Tech Advisory Number: TAMCF00026

This TA describes the new features, updates, and bugs in the latest firmware version for Merrychef connex.

Firmware version numbers

Figure 4 New diagnostic features

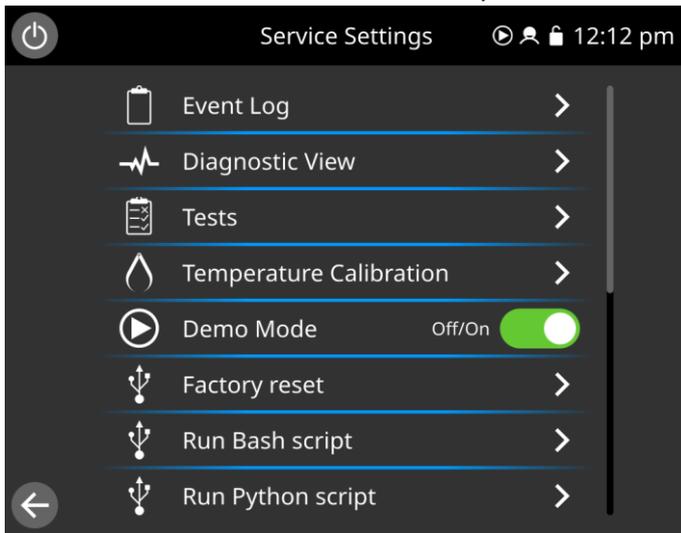
In service settings, are two new features to help the Merrychef software team run diagnostics, Run Bash Script and Run Python script. Authorised usage of these features is limited to Merrychef software trained technicians. This feature will only be utilised under explicit instruction from Merrychef Technical Services, and any unauthorized access may result in invalidation of warranty.

Figure 6 New Updates page

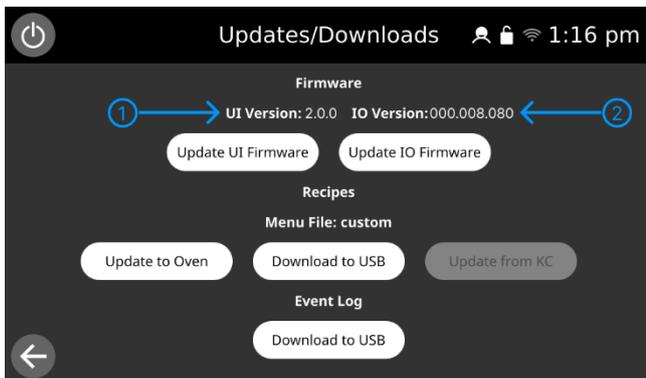
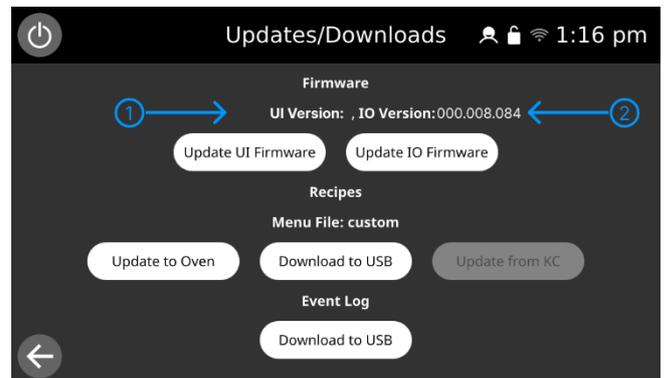
Despite our best efforts and thorough firmware regression testing, a bug has been found which will be fixed in our next release of firmware. When updating the firmware to the latest release, in some cases we have found the new UI firmware version number is not displayed after the update has been completed.

In the Old firmware updates page, both the UI Version (1) and the IO version (2) are visible.

After completing the update, the version number might not be displayed. In the New firmware updates page, the IO Version (2) has updated.

Figure 8 New About page

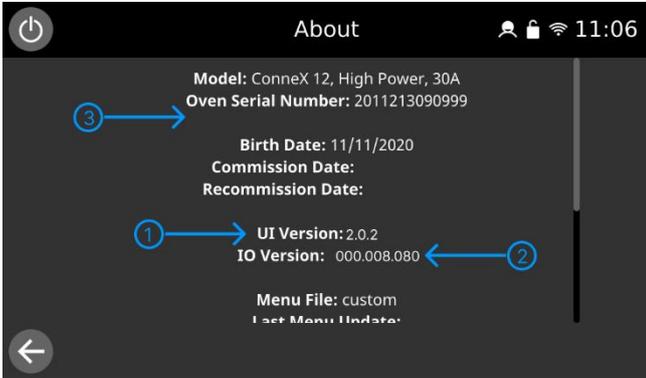
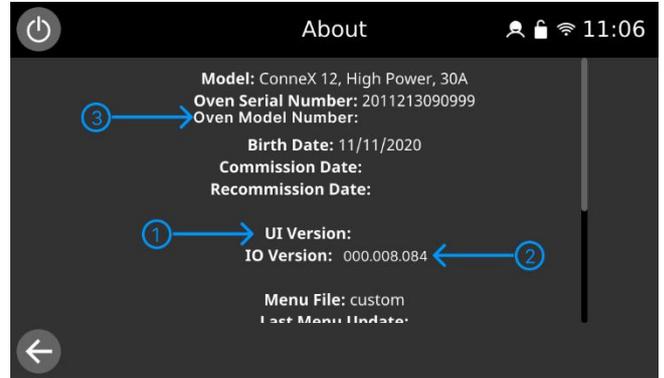
To confirm the UI firmware has updated, the about page can be referenced before and after the update.

The About screen before the update does not include oven model number (3), as this was not a feature in the older version of software.

(Note: The model number gets populated during the factory setup process. It's blank because this feature did not exist in older versions of the oven firmware when the oven was built. It has no impact on the operation of the oven.)
